Access Compliance Report

Public Rights-of-Way

Intersection ID: 46032	Main Street: DOMINION_VILLAGE_DR	Cross Street: MILLSTREAM_RIDGE_DR	Location: W
ADA ID: BCA968C14AC2	Ramp Type: PerpDiag	Initial Pass/Fail: Fail	Overall Compliance: No
Severity Score: 21.25			
Codes/Mitigation Info/Possible Solution		Field Measurements/Component Compliance

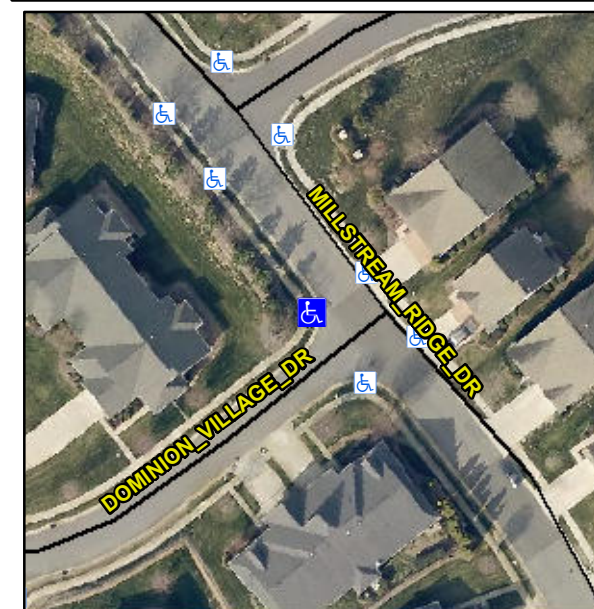
Not Found, R304.5.1, R304.5.3

Compliance	Description	Data	Compliance	Description	Data
N/A	Ramp Length (in)	49.0	Yes	Ramp Slope (%)	5.3
No	Ramp Width (in)	40.0	No	Ramp XSlope (%)	5.2
N/A	Flare Type LT	N/A	N/A	Flare Type RT	N/A
N/A	Flare Slope LT (%)	N/A	N/A	Flare Slope RT (%)	N/A
N/A	Flare Traversable LT?	N/A	N/A	Flare Traversable RT?	N/A
N/A	Landing Length (in)	N/A	N/A	DWS Provided?	N/A
N/A	Landing Width (in)	N/A	N/A	DWS Contrast?	N/A
N/A	Landing Slope (%)	N/A	N/A	DWS Length (in)	N/A
N/A	Landing X Slope (%)	N/A	N/A	DWS Full Width?	N/A
N/A	Landing Curb? (Y/N)	N/A	N/A	DWS Offset (in)	N/A
N/A	Shared Landing?	N/A			
N/A	Gutter Ponding?	N/A	N/A	Gutter Slope (%)	N/A
N/A	Gutter Lip Ht (in)	N/A	N/A	Gutter X Slope (%)	N/A
N/A	Painted X Walk1?	No	N/A	Painted X Walk2?	No
	X Walk 1 Direction	To SE		X Walk 2 Direction	To NE
N/A	X Walk 1 Width (in)	N/A	N/A	X Walk 2 Width (in)	N/A
	X Walk 1 Slope (%)	1.1		X Walk 2 Slope (%)	6.4
	X Walk 1 X Slope (%)	6.9		X Walk 2 X Slope (%)	1.7

Remove & Replace Curb Ramp With Two New Directional Ramps or Equivalent.
